CARLO GAVAZZI SPACE SpA		RELAZIONE DI RIUNIONE / VISITA MINUTES OF MEETING / VISIT		N° AMS02-MI-CGS-003 FOGLIO SHEET 1 DI OF 5 ANNEX #A	
DATA - DATE 23-24/10/07		LOCALITA' - LOCATION PISA		COMMESSA - JOB 2011I	
IMPIANTO PROJECT	DESCRIZIONE DESCRIPTION AMS TCS				CLIENTE - CUSTOMER
	LOCALITA' LOCATION INFN - PISA				ORDINE - CONTRACT
SCOPO RIUNIONE PURPOSE OF MEETING	Heaters and thermostats integration on E crate				REDATTO - WRITTEN BY A.Assenza
					LISTA DI DISTRIBUZIONE DISTRIBUTION LIST M.Molina
					C.Vettore
					C.Canella
PRESENTI - ATTENDED BY	NOMI - NAMES		POSIZIONE - POSITION		M. Olivier
	F.Cervelli – INFN Pisa (24.10.07)				L.Cremonesi
	F.Spinella – INFN Pisa				F.Facchin
	Antonella Assenza - CGS				G.Borghi
	Claudio Canella- CGS				A.Dell'acqua
					P.Lorenzi
PUNTI ITEMS	ARGOMENTI DISCUSSI – DESCRIPTION OF DISCUSSION				AZIONE A CURA ¹⁾ ACTION BY ¹⁾

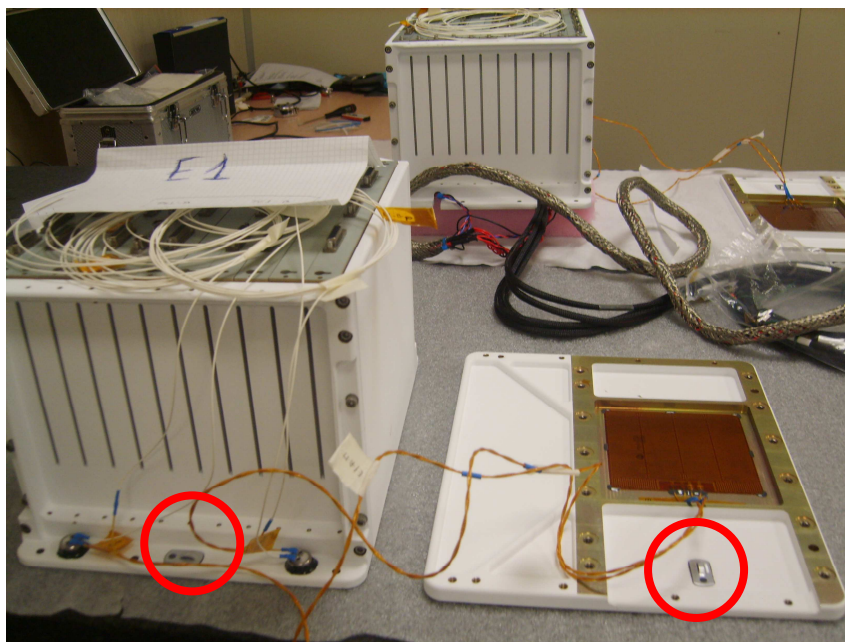
two metallic cable-ties have been glued on each set (1 on E crate , between the 2 thermostas, and 1 on related support plate, as shown on picture below.

This to provide an interface where to tie the cables bundle in a proper way when needed

ANNEX#A : CABLE SLOT with blend R=0.5mm

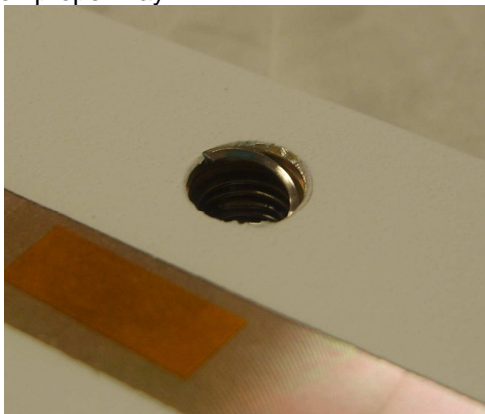
- CGS notes that cable bundle on E0 crate can have problem with cable slots dimension on lower wall ; this problem was encountered also on other AMS crates and then cable slots enlarged.

- Slot edges seems to be sharp :

A blend radius R=0.5 is foreseen in all edges for cable slots on crate lower main walls

•Parts already manufactured →NCR
If is not feasible to round the edges without damage the parts ,the alternative solution is a chamfer 0.5x45°, that can be done by hand (hand tool, sand paper,...)

23.10.07
CGS suggest to check the real FM cable bundle dimensions and in case of interference to split the cables in order to use also the second cable slot ; this to avoid reworking of main wall
